**PRODUCT PIPING &
VAPOR RETURN PLAN**

SHEET OF SHEETS	<p>BP OIL CO. <i>1716 Webster St.</i> SEC BUENA VISTA AVE. & WEBSTER ST. ALAMEDA CALIFORNIA</p>	
JOB NO. 10-3485

WEBSTER ST. & BUENA VISTA AVE.

SITE PLAN

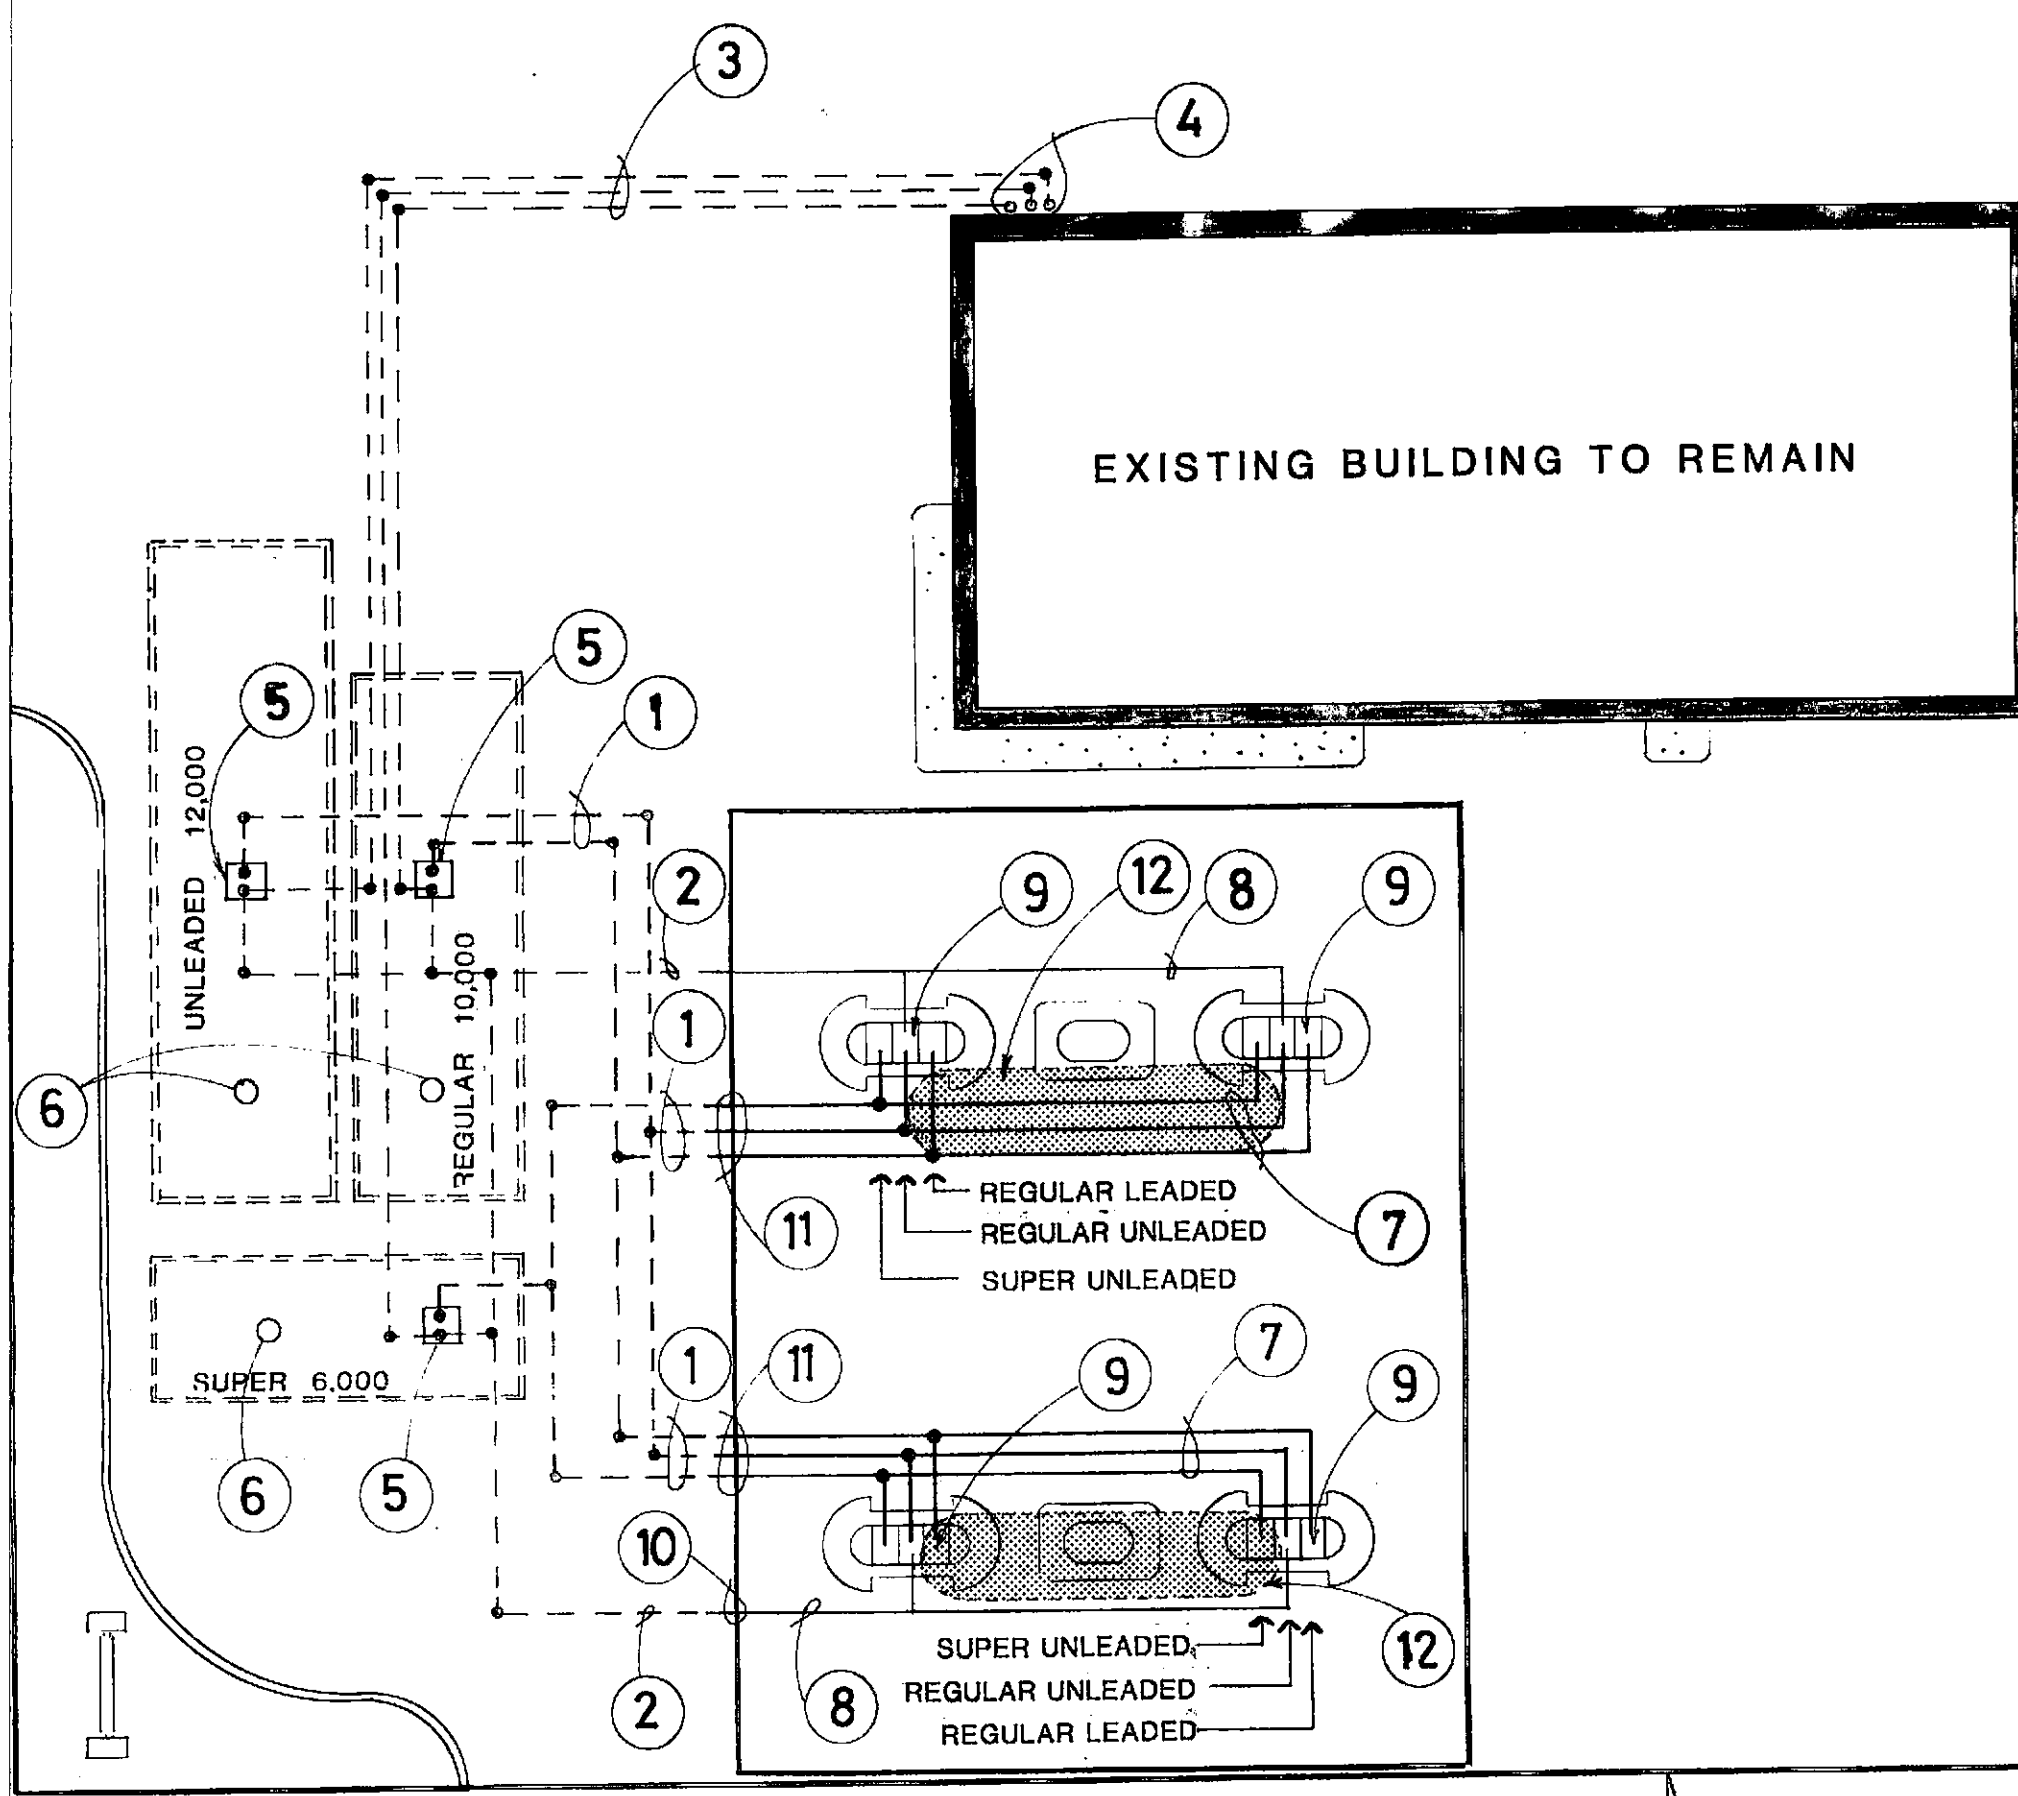
1. Existing product piping is ~~double contained with trench liner.~~ *single walled (fiberglass?)*
2. Modified product lines shall be contained with fiber trench liner or equal per manufacturers requirements.
3. Existing underground tanks are ~~double~~ *single* wall fiberglass.
4. G.C. to saw cut drive slab as required to install new petroleum piping. Patch concrete as needed.

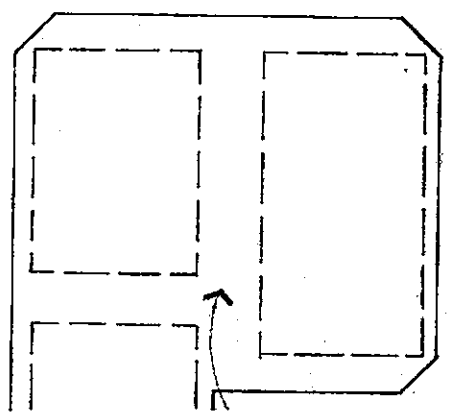
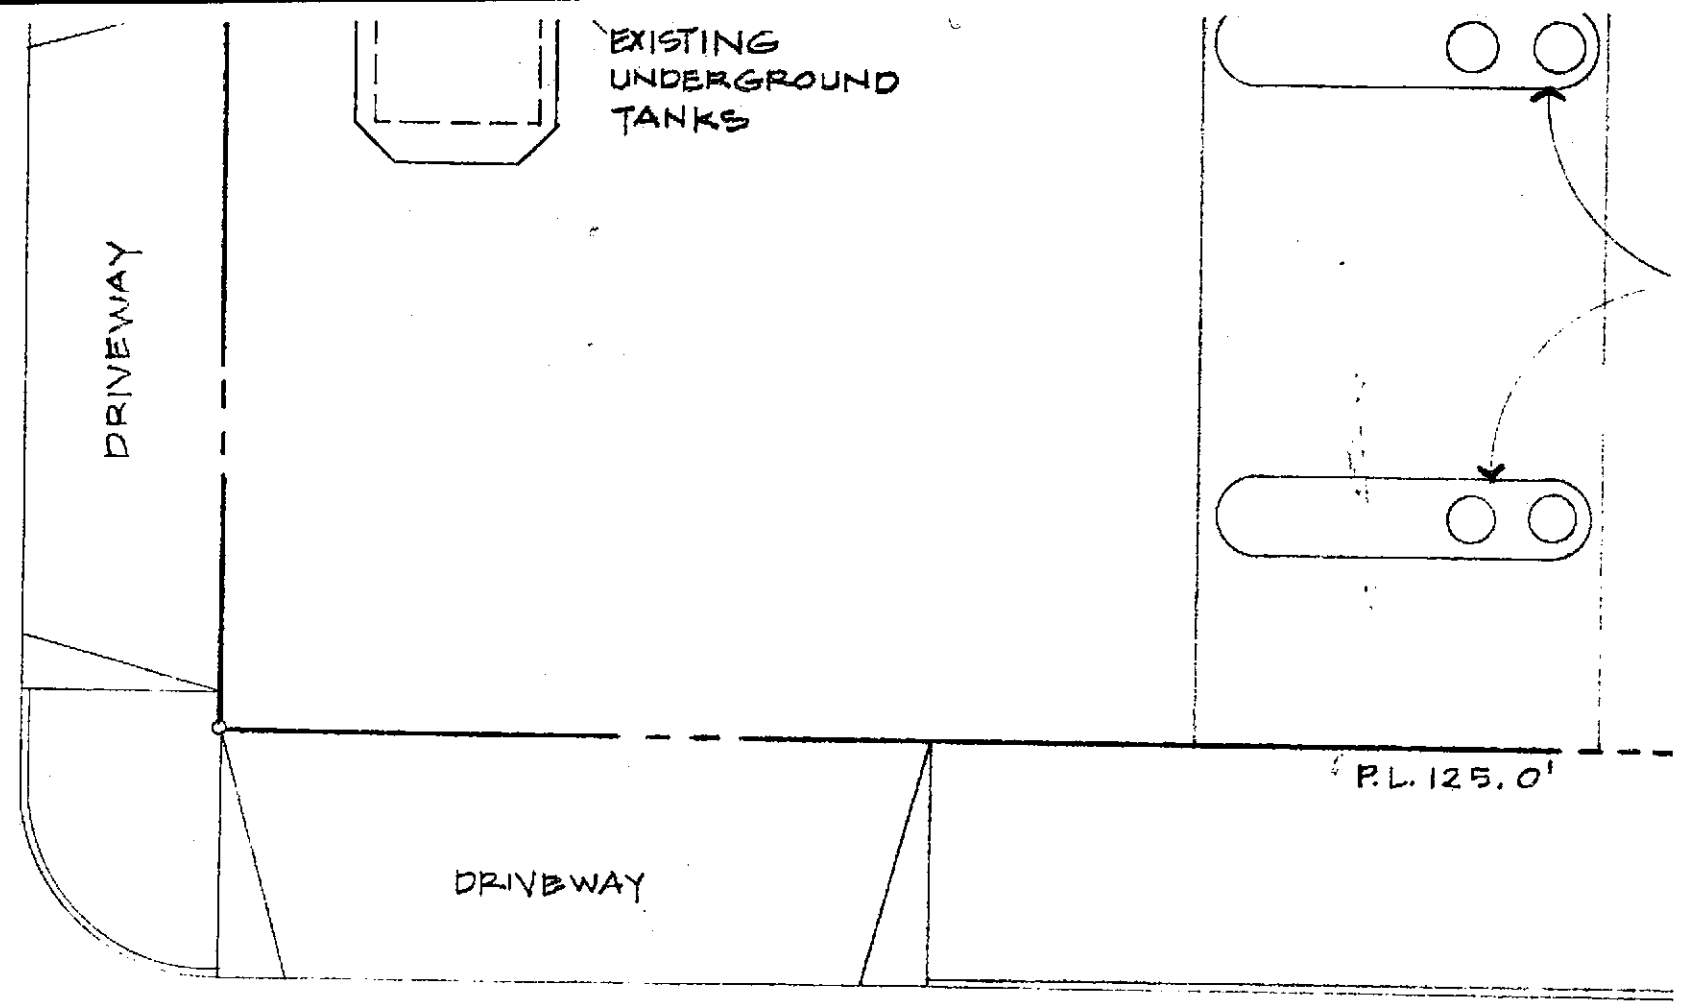
*I would like a
radon well in the
backfill - one would be plenty
J.M. Garrow
3/5/87*
